Luensmann Offsite Water Main Ext PH1
Solicitation Number: CO-00717
Job No.: 23-1043

ADDENDUM 1
11/16/2023

PLAT NO.
JOB NO. 12473-09
DATE MARCH 2023
DESIGNER CD
CHECKED MP DRAWN CD
SHEET C3.09

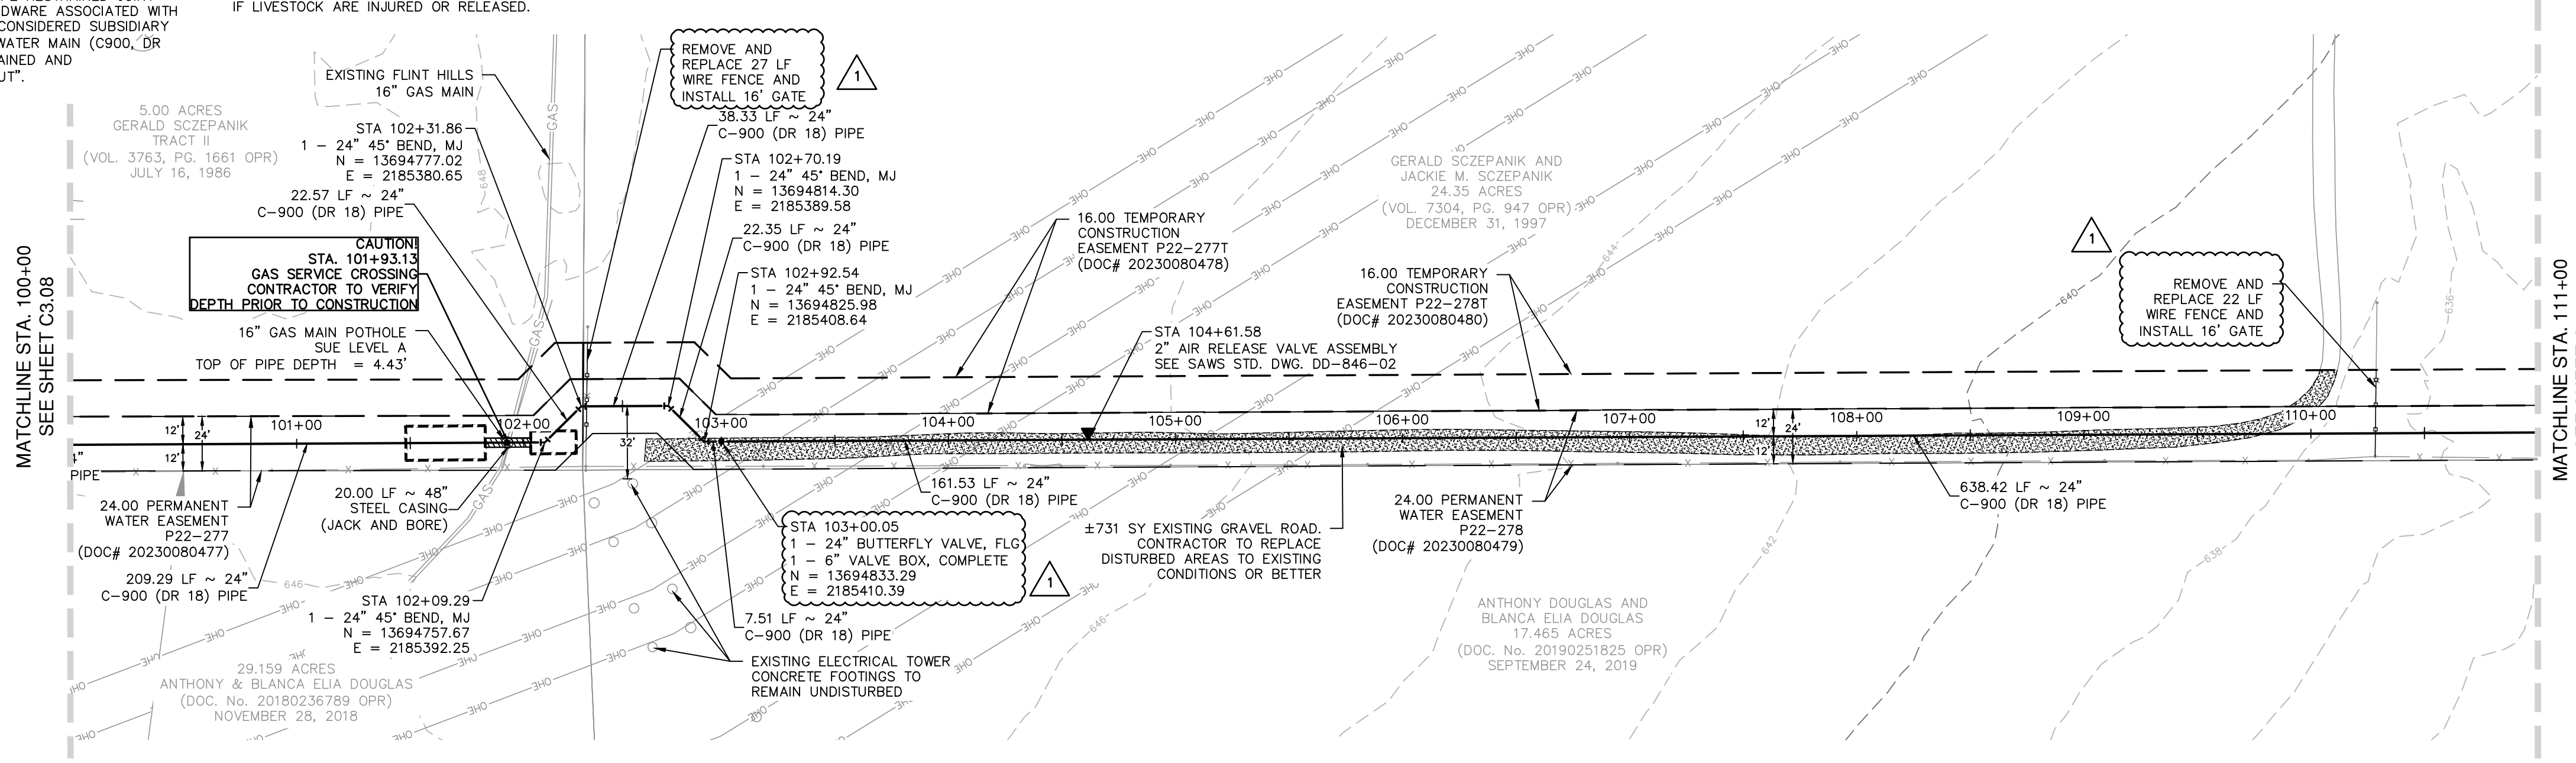
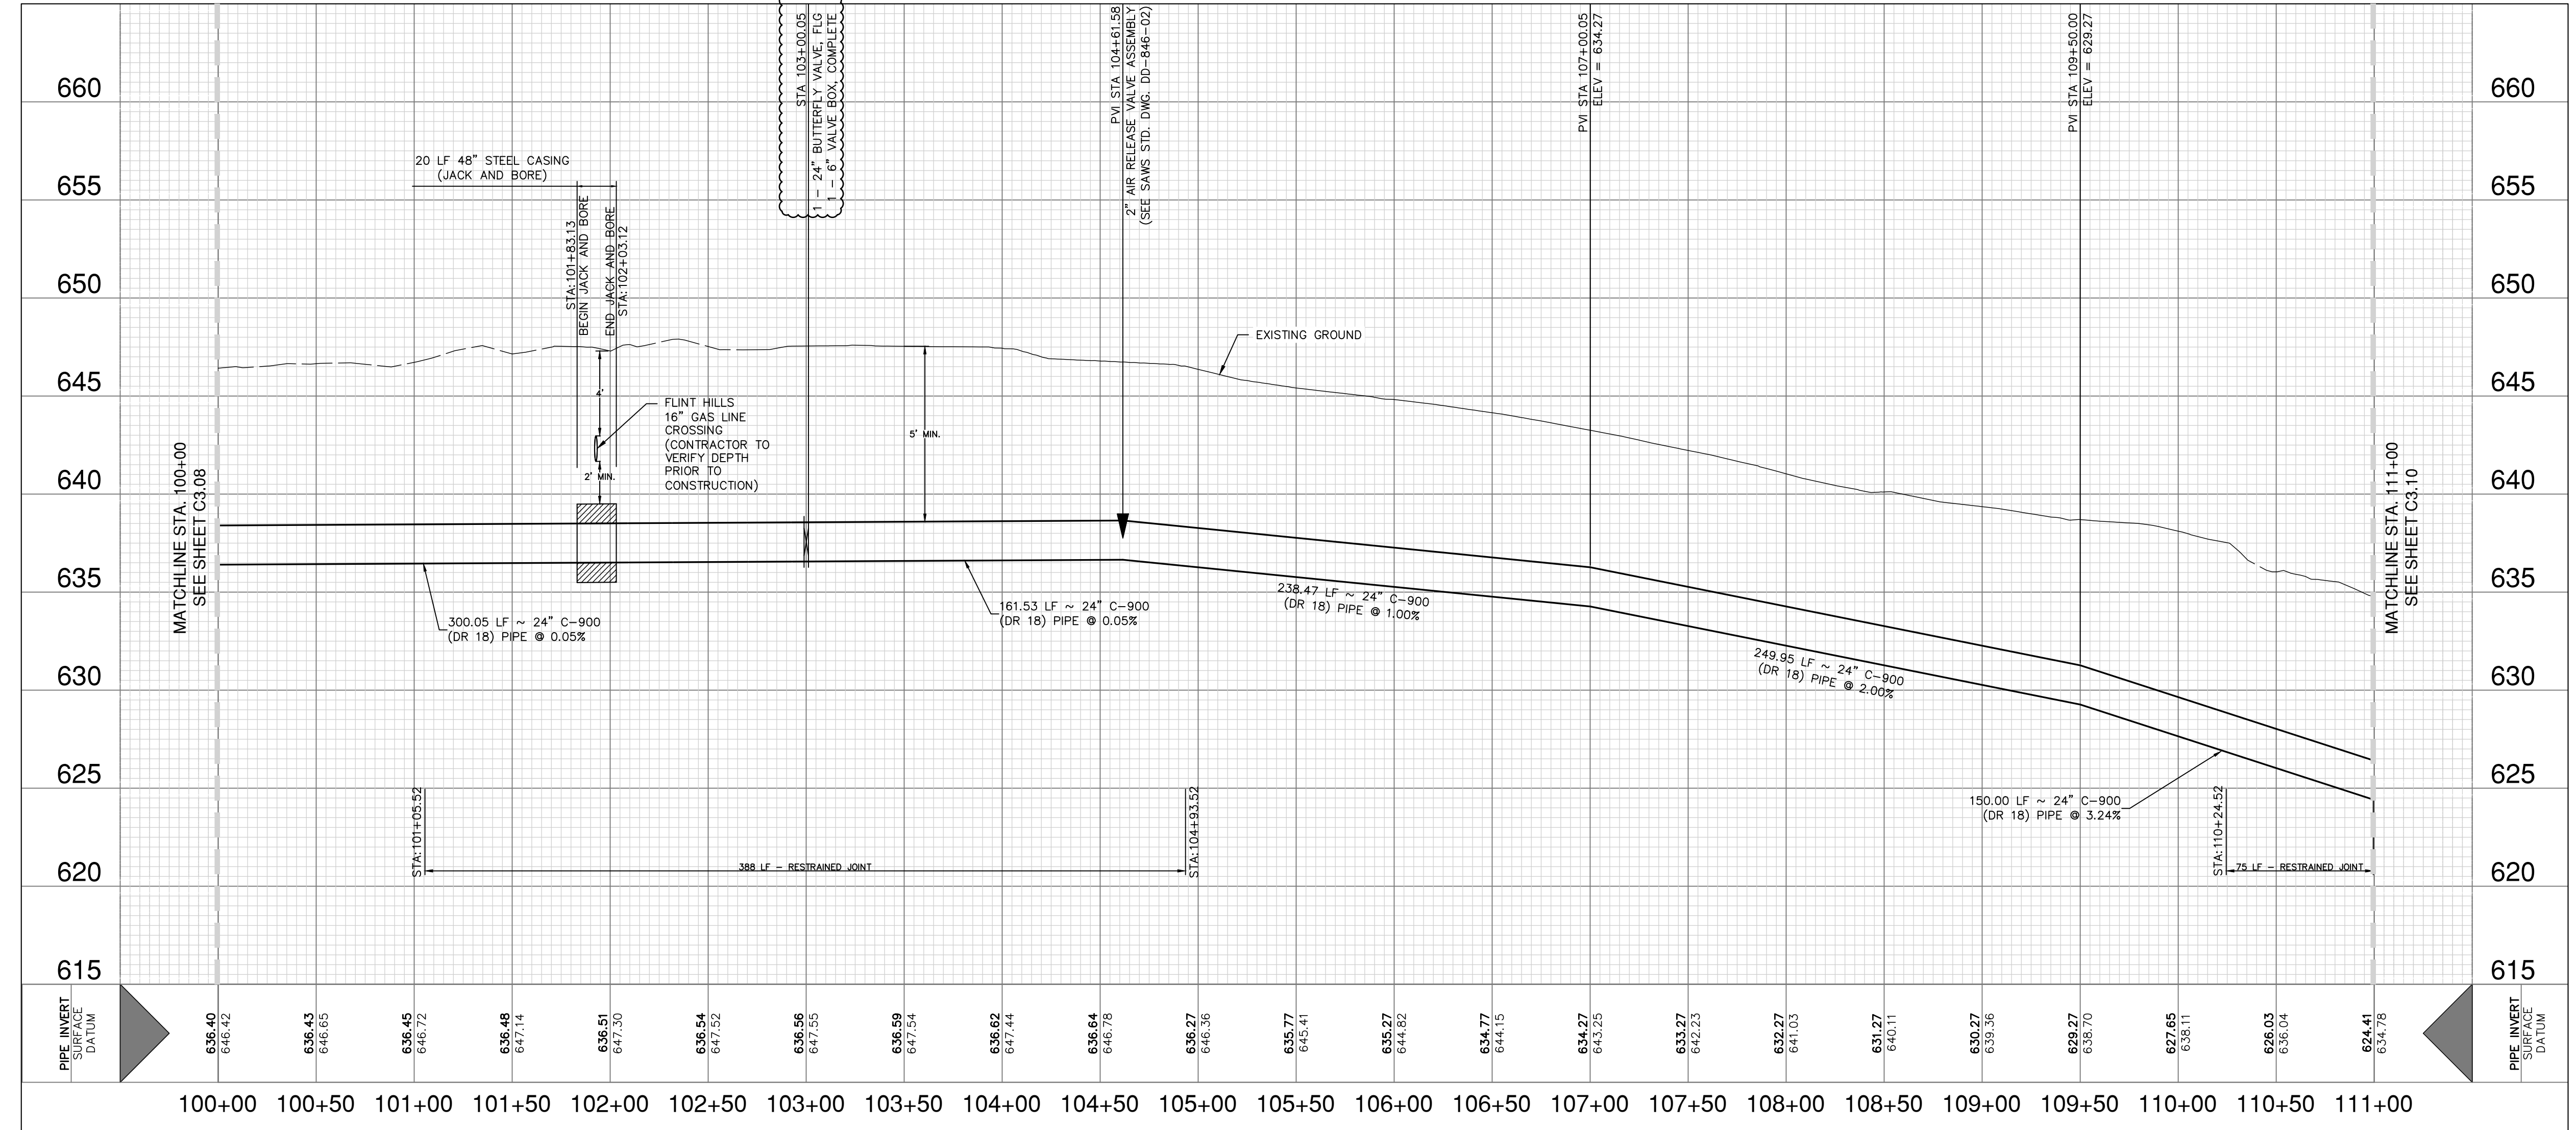
- Updated quantity table to add a Fence Gate Type 1 and Remove and Replace Existing Fence
 - Revised 24" Butterfly valve to be Flanged.
 11. Sheet C3.09: Water Main Plan and Profile Sta 100+00 to 111+00 – Remove in its entirety and replace with the attached document.

SHEET: C3.10

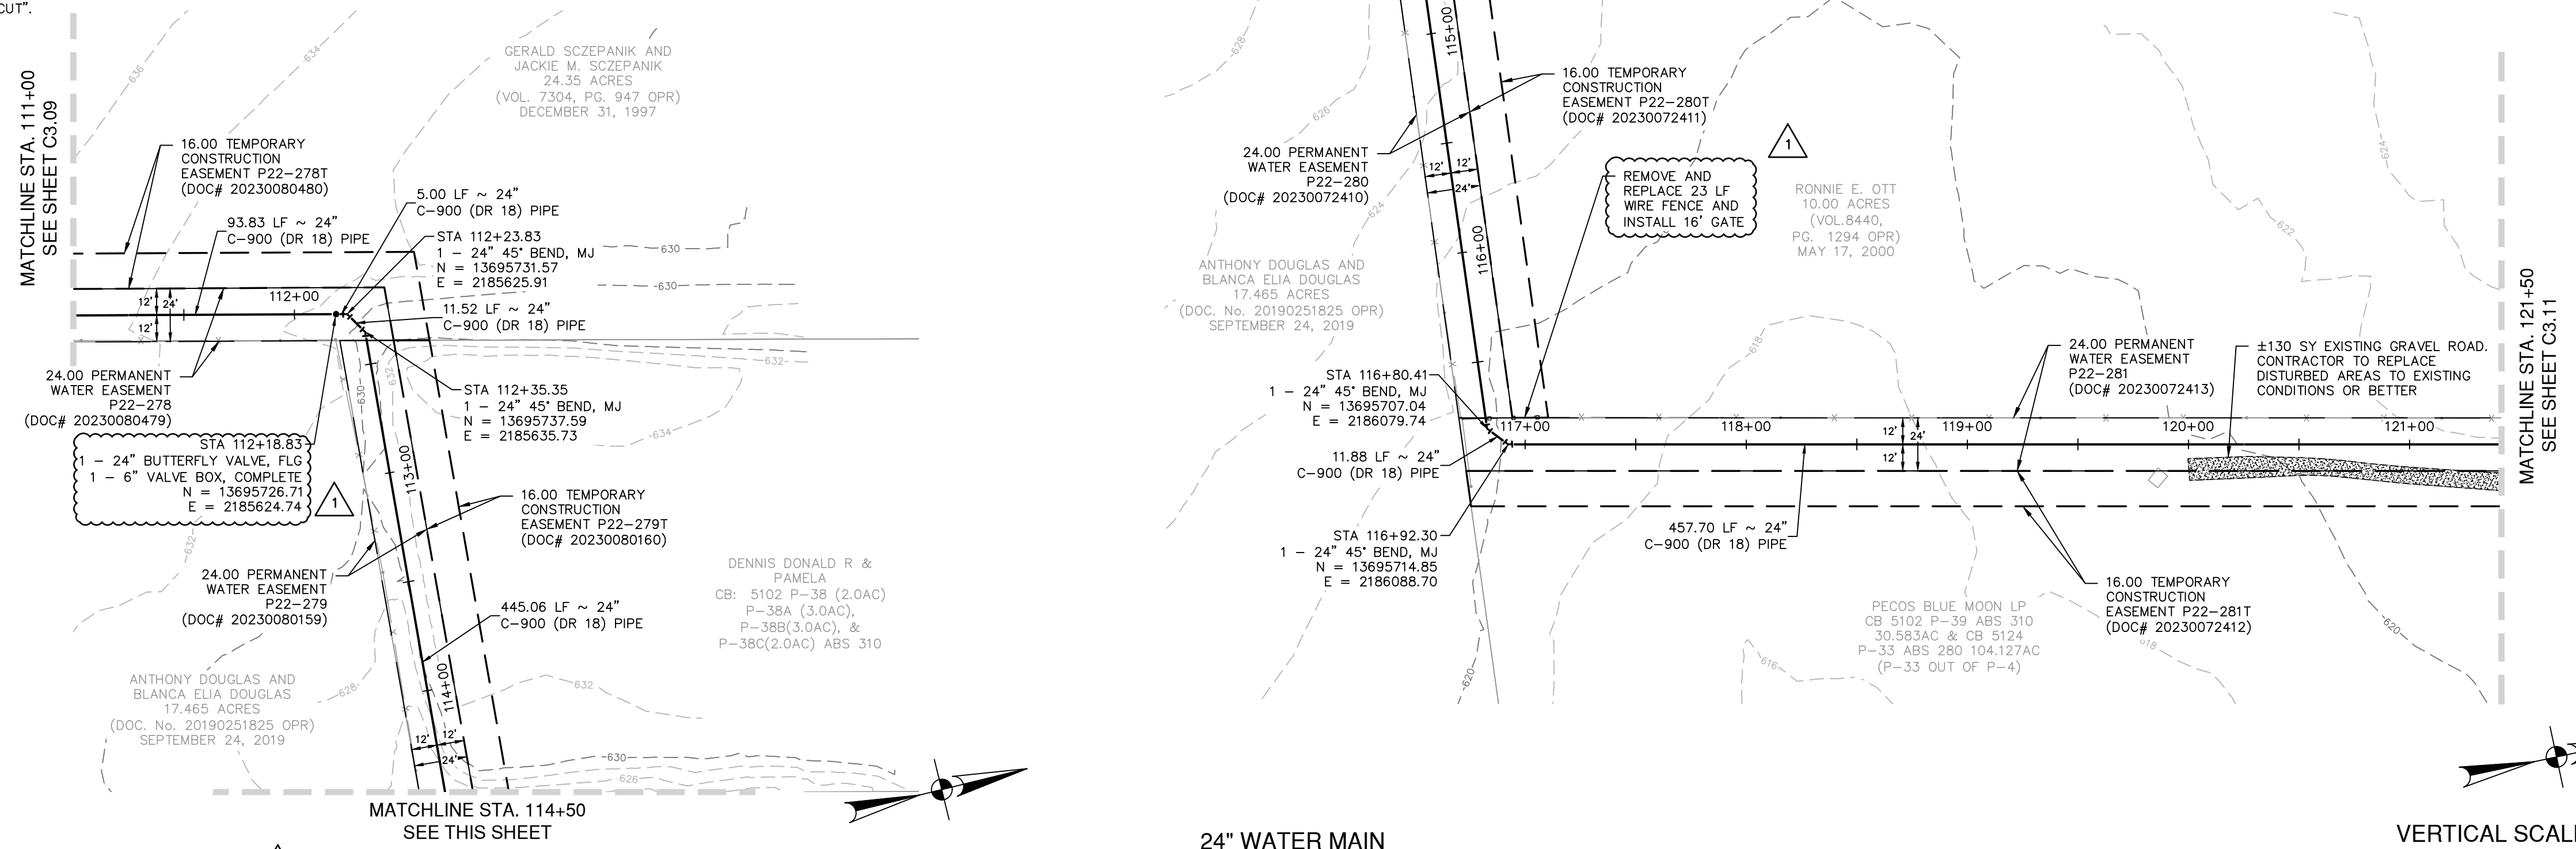
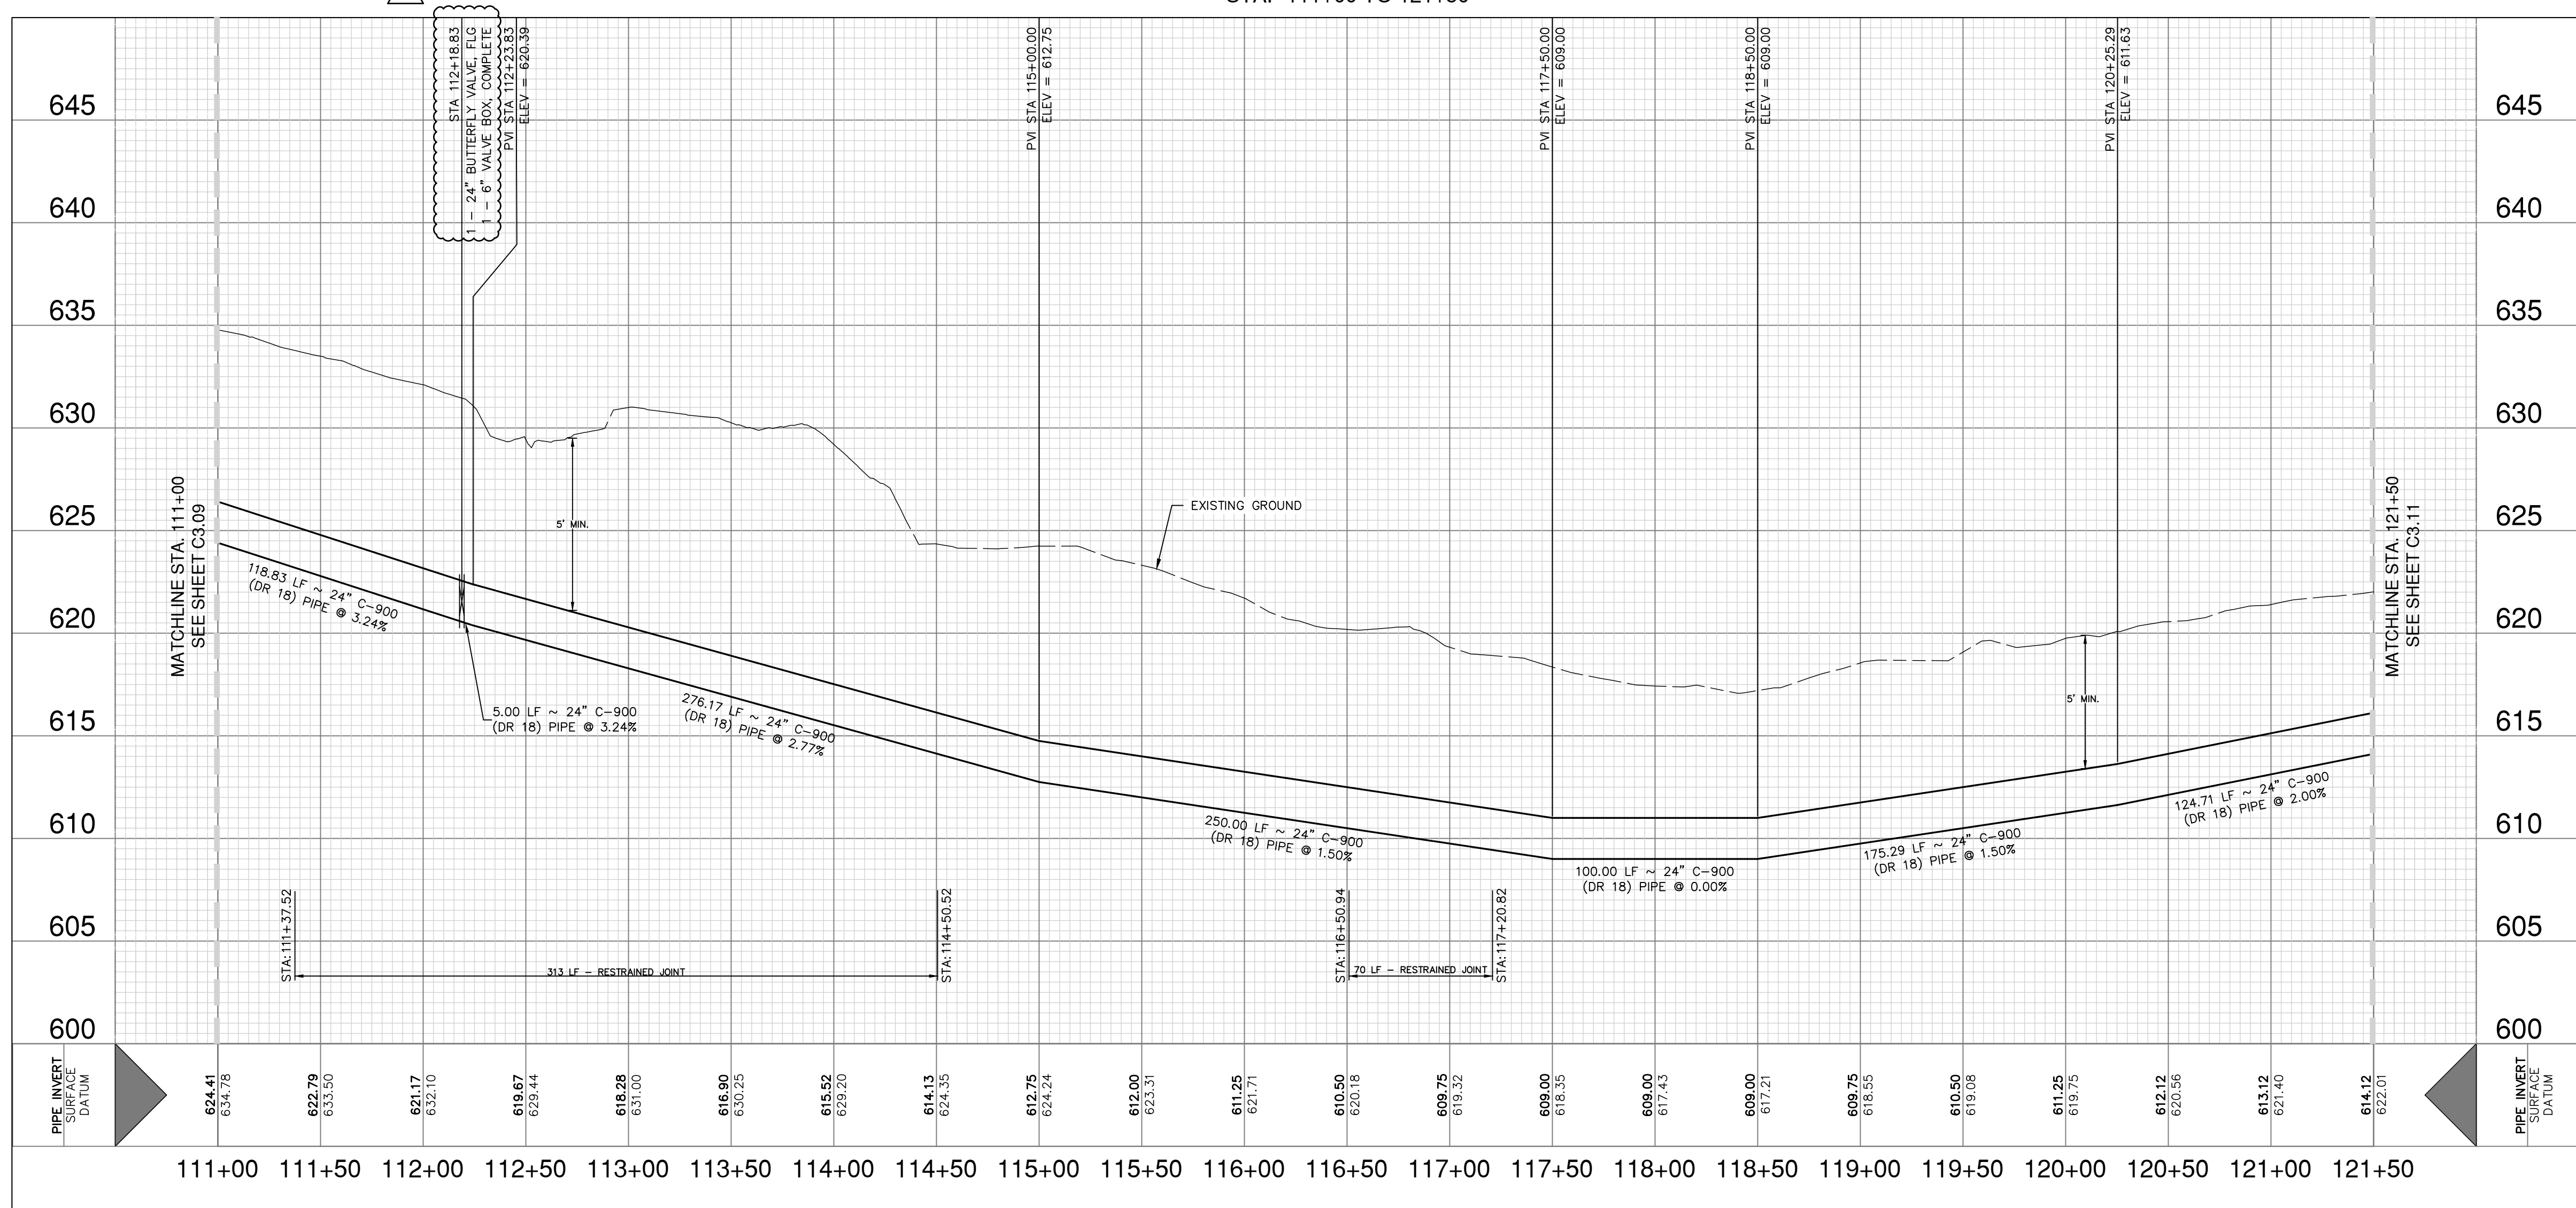
- Updated quantity table to add a Fence Gate Type 1 and Remove and Replace Existing Fence
 - Revised 24" Butterfly valve to be Flanged.
 13. Sheet C3.10: Water Main Plan and Profile Sta 111+00 to 121+500 – Remove in its entirety and replace with the attached document.
